June 17, 2015

To: Plan Holders for Improvements to the
Northwest Missouri Regional Airport
Maryville, Missouri
Project No. 14-002A-1
Reconstruct Runway 14/32 (Schedule I), Reconstruct Connecting Taxiway (Schedule II), and Partial Apron (Schedule III)

**ADDENDUM NO. 1
TO
CONTRACT DOCUMENTS, PLANS AND SPECIFICATIONS
FOR IMPROVEMENTS TO THE
NORTHWEST MISSOURI REGIONAL AIRPORT
MARYVILLE, MISSOURI
PROJECT NO. 14-002A-1**

SHEET NAME
G002
SHEET NO.
2 of 76

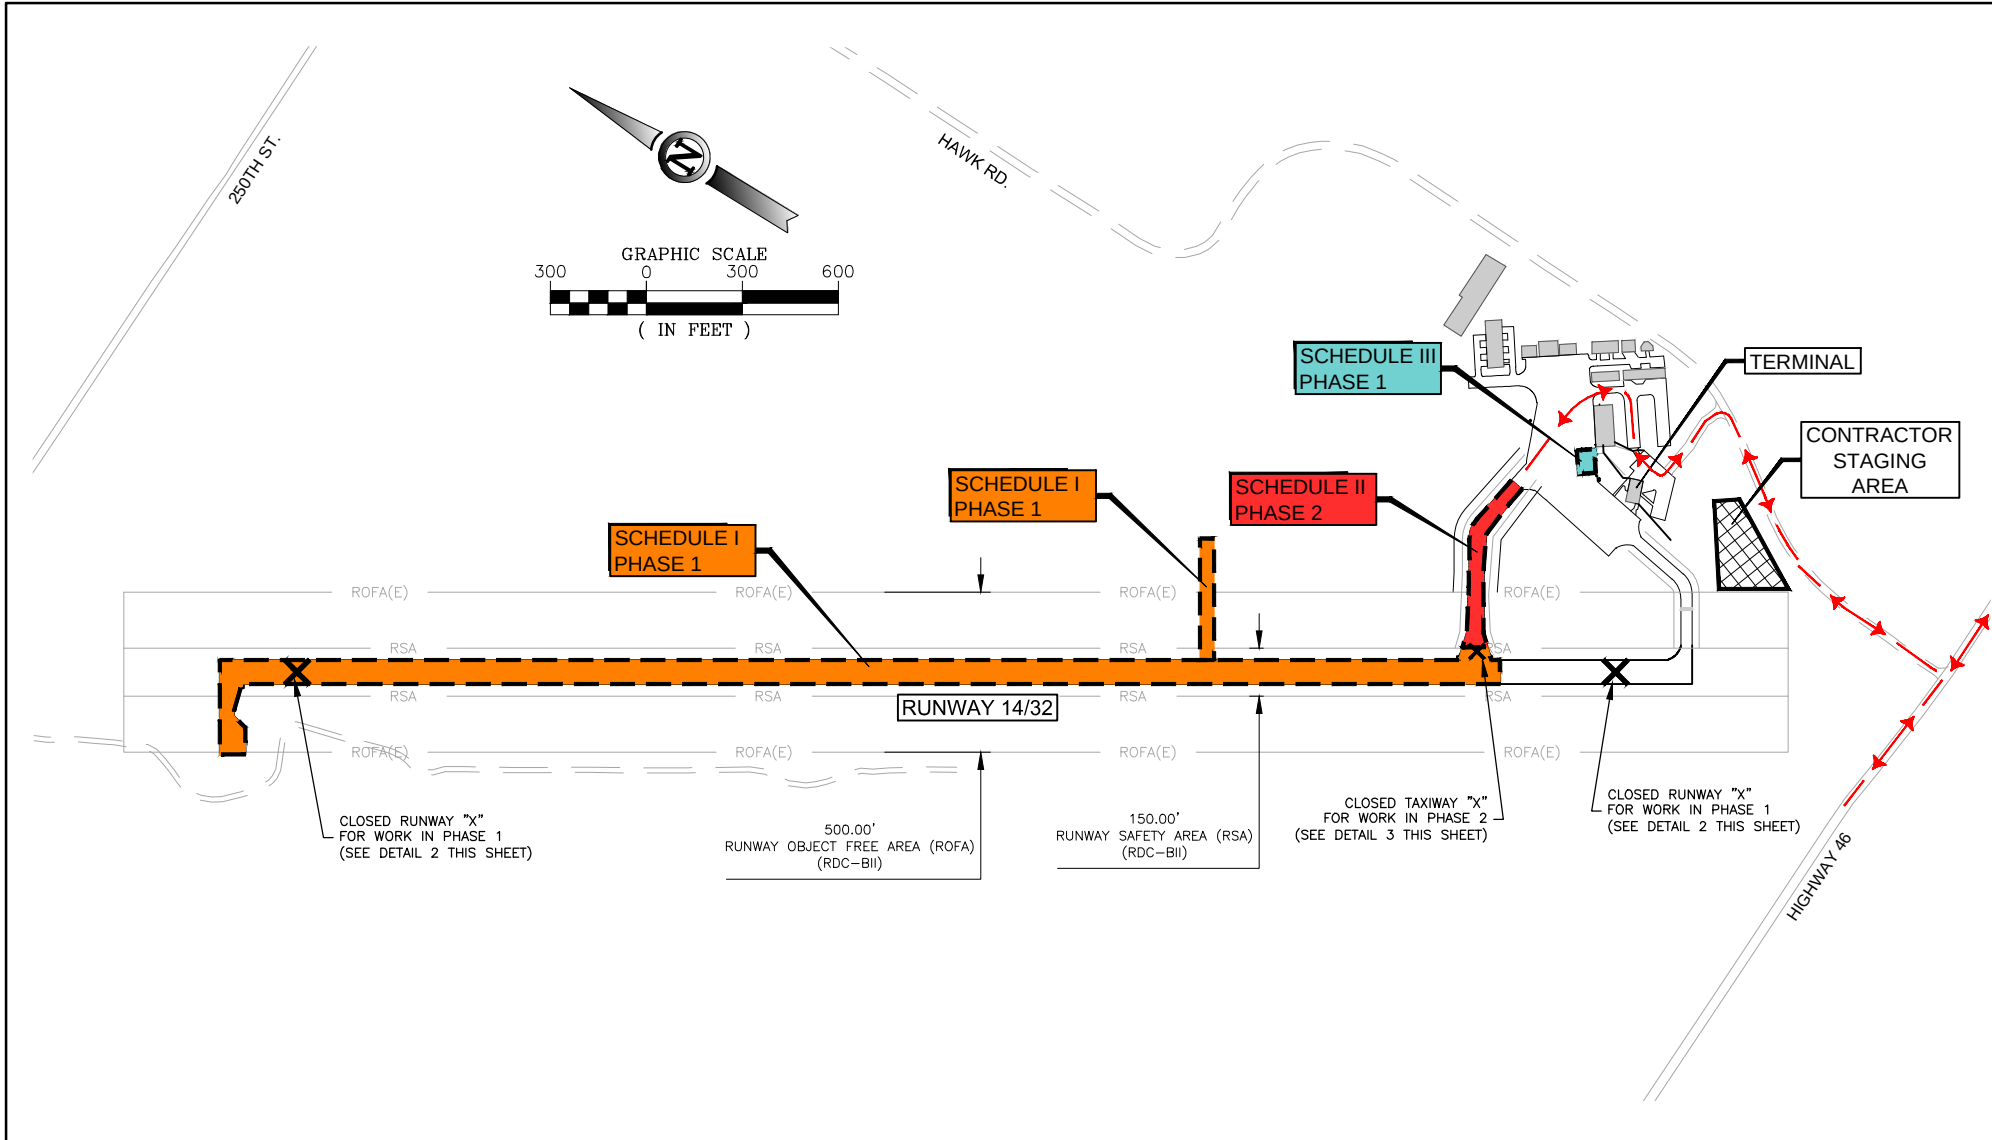
Revision: The Unclassified Excavation Volume Calculation detail has been revised to reflect the two Bid Alternates for use of Recycled Concrete Aggregate Base or New Crushed Aggregate Base. In addition, Lime Stabilization has been replaced with Fly Ash Stabilization.
See attached sheet G002.

2
G010
CLOSED RUNWAY "X"
N.T.S.

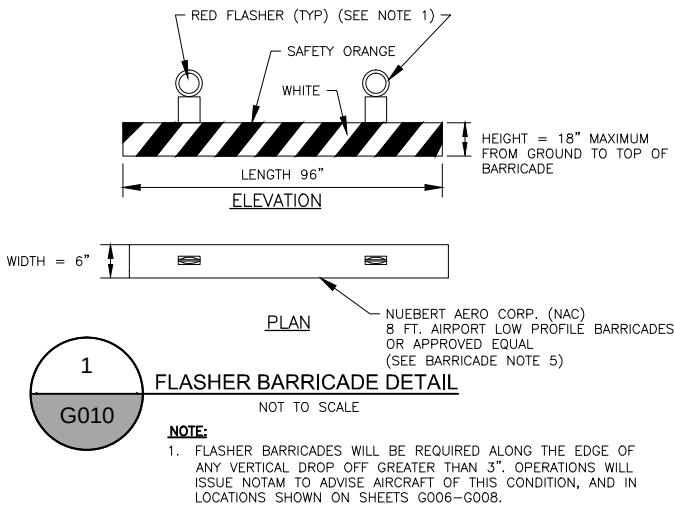
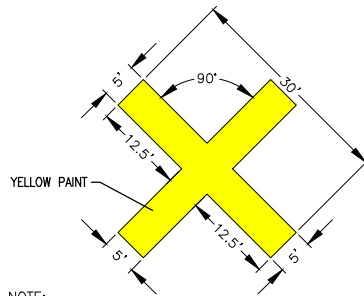
Sheet: G010
Title: Construction Safety Drawing Overall Phasing Plan
Revision: All references to the Estimated Start Date have been revised to read: "ESTIMATED START DATE: SUMMER 2015 OR SPRING 2016 (TENTATIVELY SCHEDULED FOR MAY 2, 2016)".
See attached sheet G010.

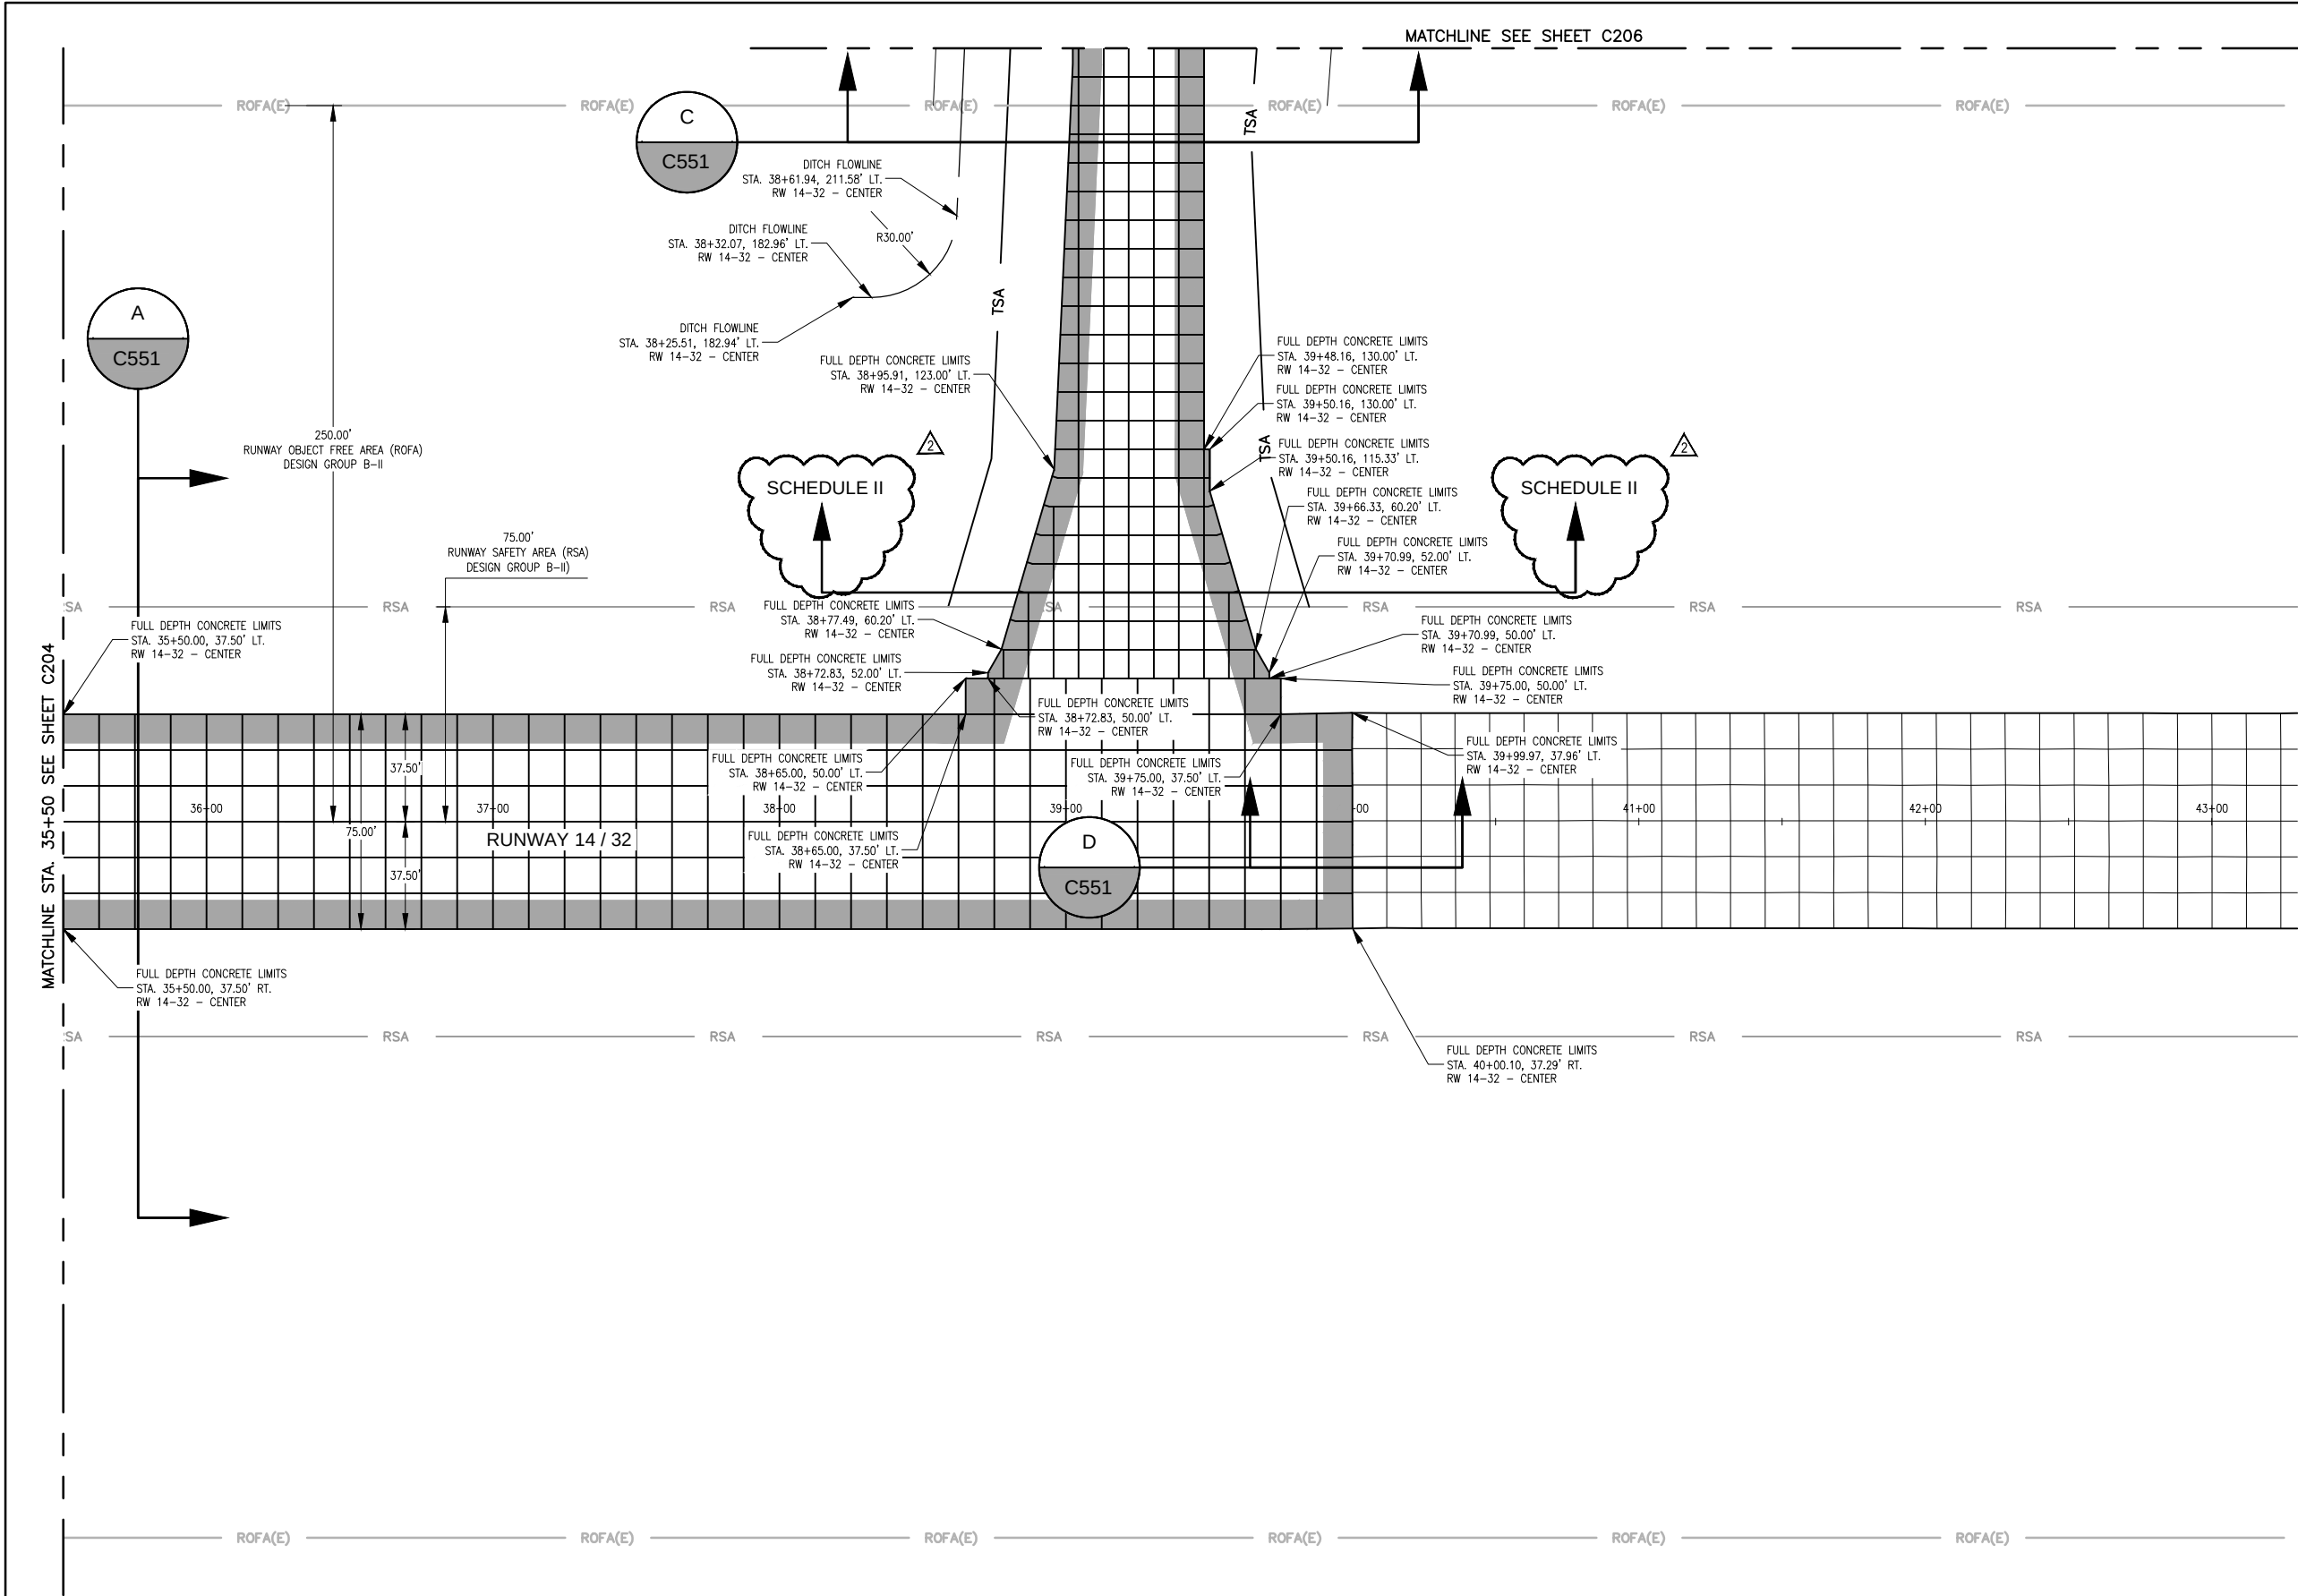
Sheet: C205
Title: Geometric Plan Sta. 33+50 to Sta. 40+00 Runway 14/32
Revision: This sheet has been revised to clarify the limits of Schedule I and Schedule II.
See attached sheet C205.
